UN#09-364

Subject: UniStar Nuclear Energy, NRC Docket No. 52-016
Response to Request for Additional Information for the
Calvert Cliffs Nuclear Power Plant, Unit 3,
RAI No. 58, Seismic Design Parameters, Questions 03.07.01-3 and 03.07.01-5

**Response to NRC Request for Additional Information,
Seismic Design Parameters, Questions 03.07.01-3 and 03.07.01-5,
Calvert Cliffs Nuclear Power Plant, Unit 3**

Figure 1. Randomized Shear-Modulus and Damping Degradation Curves for Terrace Sand Material Used for Assumed Structural Backfill.

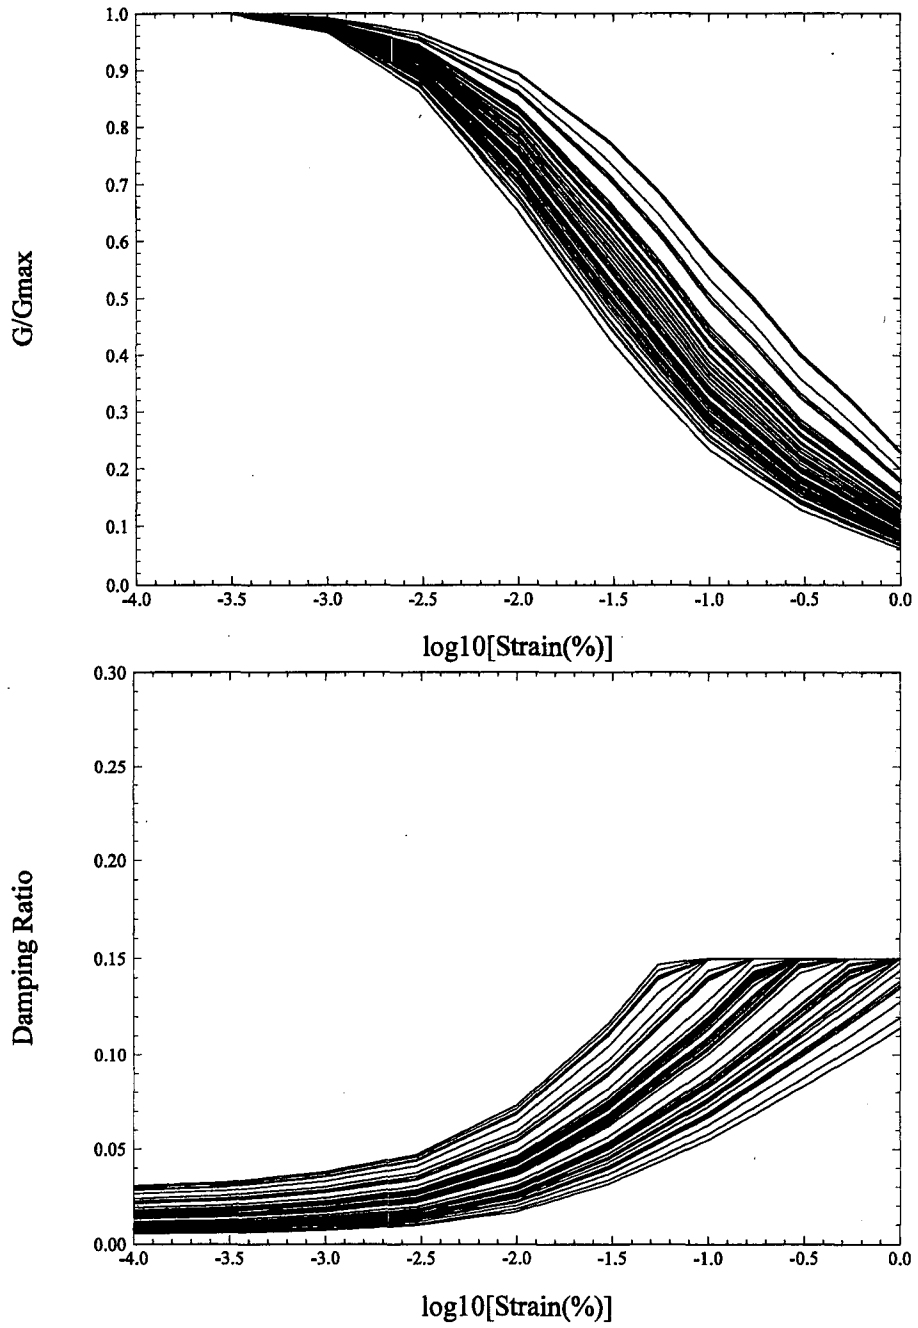
- How were the FIRS at grade elevation computed from the GMRS which were determined at an elevation 12.5 m (41 ft) below grade? Include in the response, computer codes, soil column model, and the basis for the shear wave velocity of the structural backfill that supports both the EPGB and ESWB and the impact of this backfill on the development of the FIRS?

Soil profile provided in FSAR Tables 2.5-51 and 2.5-53 is used for depths greater than 41 ft. The structural backfill properties considered in the analysis for the top 41 ft are provided in Table 1. The shear-wave velocity used for the top 41 ft of backfill corresponds to the in-situ soils (25 ft of Terrace Sands above 16 ft of Chesapeake clay/silt). Due to unavailability of the actual backfill properties, these values were considered representative of the structural backfill material at the time of writing the FSAR. Similarly, the unit weight and degradation curves for the Terrace sands were also considered representative of the backfill properties (see FSAR Table 2.5-53 and Figure 1 below). The dynamic properties for the in-situ soils are based on Resonant Column Torsional Shear (RCTS) Tests and are randomized as shown in Figure 1.

Figure 4: Calvert Cliffs Site SSE 5% damping spectrum (horizontal and vertical)

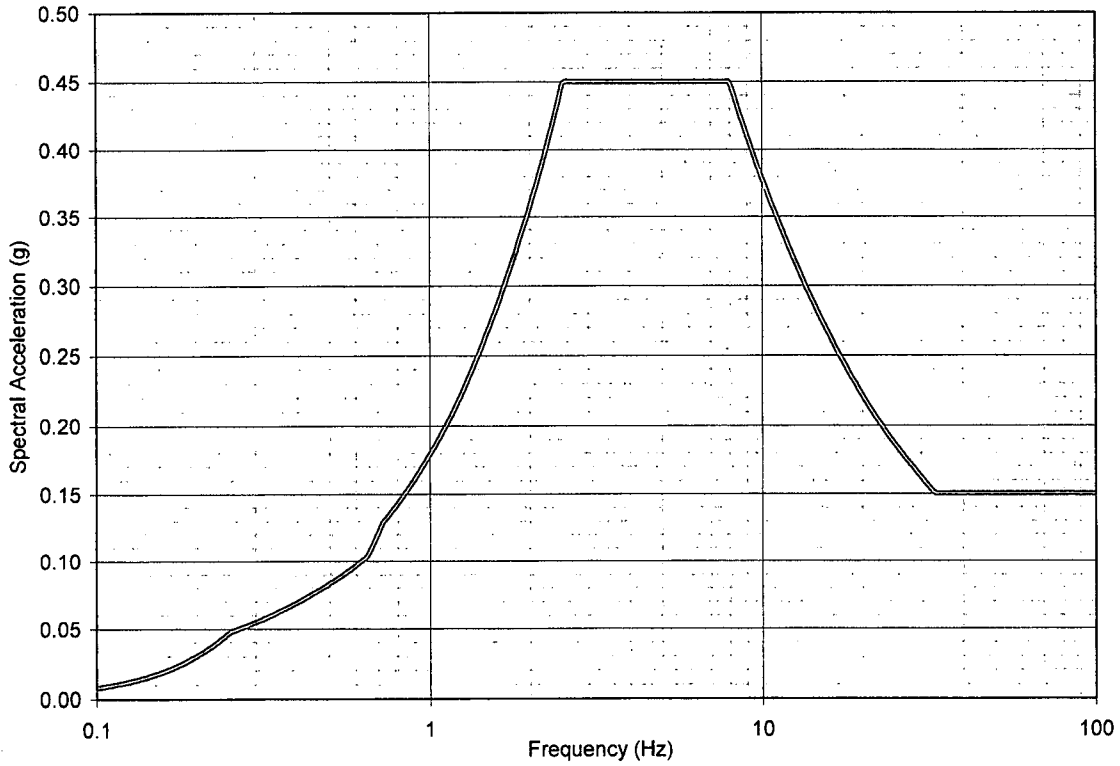
In FSAR Section 3.7.1.1.1 on page 3.0-33, it states that the design response spectra for the Ultimate Heat Sink Electrical Building (UHS EB) is conservatively established by an envelope of half the magnitude of the EUR soft soil spectrum with a zero period acceleration (ZPA) of 0.15 g and the In-Structure Response Spectra (ISRS) developed at the operating deck of the UHS makeup water intake structure (UHS MWIS). Since this is the seismic design input for this structure, provide and include in the FSAR the horizontal and vertical spectra depicting these design spectra envelopes. In addition, provide in the FSAR a reconciliation of the design response spectrum with the horizontal foundation input response spectra (FIRS) for this structure which meets the minimum requirements of 10 CFR Part 50, Appendix S. Also, include a description of how the FIRS are developed including the soil model, soil properties, backfill properties, computer programs and analysis assumptions.

Figure 4 depicts the one set of horizontal and vertical Calvert Cliffs Site SSE spectra, which replaces the two sets of spectrum described above and included in FSAR Section 3.7.1.1.1. This spectrum will be used for the SSI analysis of the UHS EB integrated with UHS MWIS and other structures in the vicinity. The development of this smooth broad band spectrum is discussed in the response to RAI 58 Q03.01.07-4¹. The results of the SSI reconciliation analysis and justification of Calvert Cliffs Site SSE spectrum as design spectra for UHS EB will be provided at a future date with responses to RAI No. 65 Questions 03.07.02-4 and 03.07.02-12 according to the schedule provided in Enclosure 1.
